AIR - HPT/LPT ACC VALVE ACTUATOR - INTRODUCTION OF A NEW SEAL RING TO HPT/LPT ACC VALVE ACTUATOR - CATEGORY CODE 6 - MOD.ENG-75-0059

V2500-ENG-75-0059

## SERVICE BULLETIN

Family Tree - HPT/LPT ACC Valve Actuator Ref. Catalog Sequence No. 75-24-52 Fig. 01,  
Item 100 (Part Number 5860017)  
Fig.1 (Sheet 1 of 2)

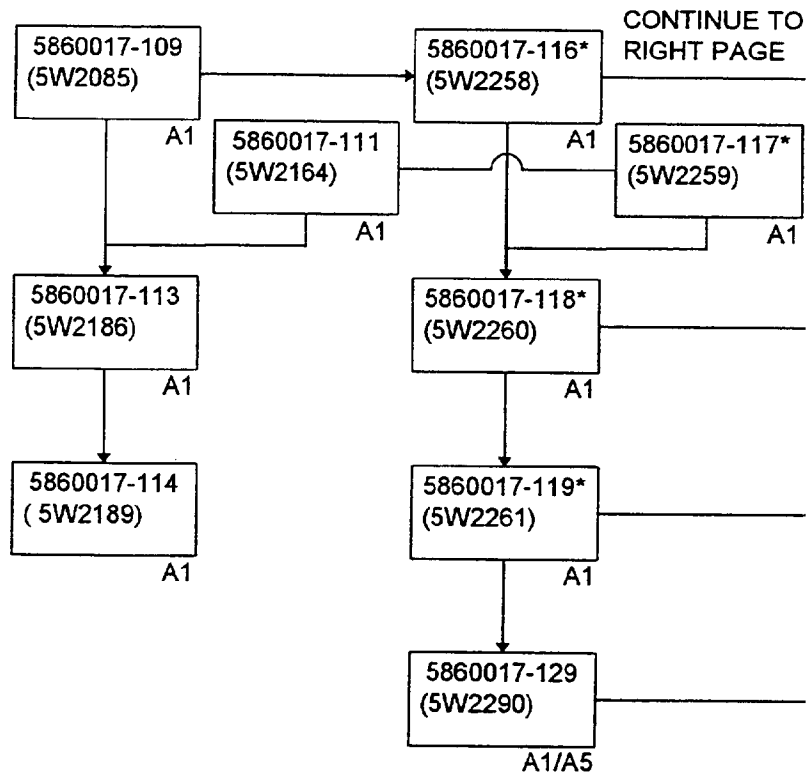
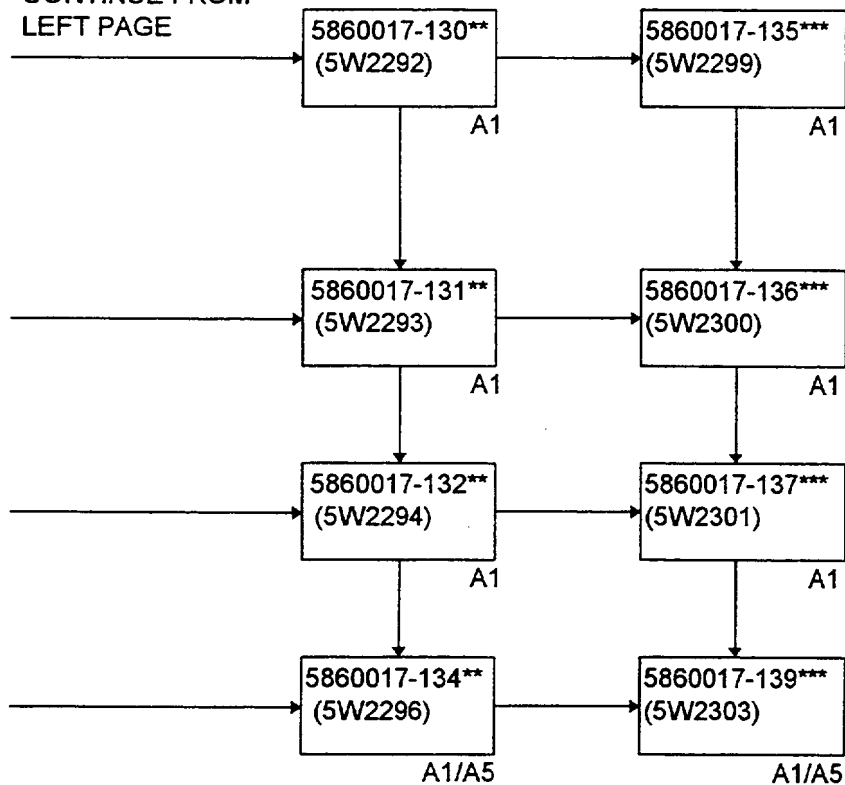
SB75-0059  
(PARKER 5860017-75-94)  
REPLACEMENT OF SEAL RINGS

PART NUMBERS WITH " \* " MARK  
SHOW THE PARTS INCORPORATED THIS MODIFICATION
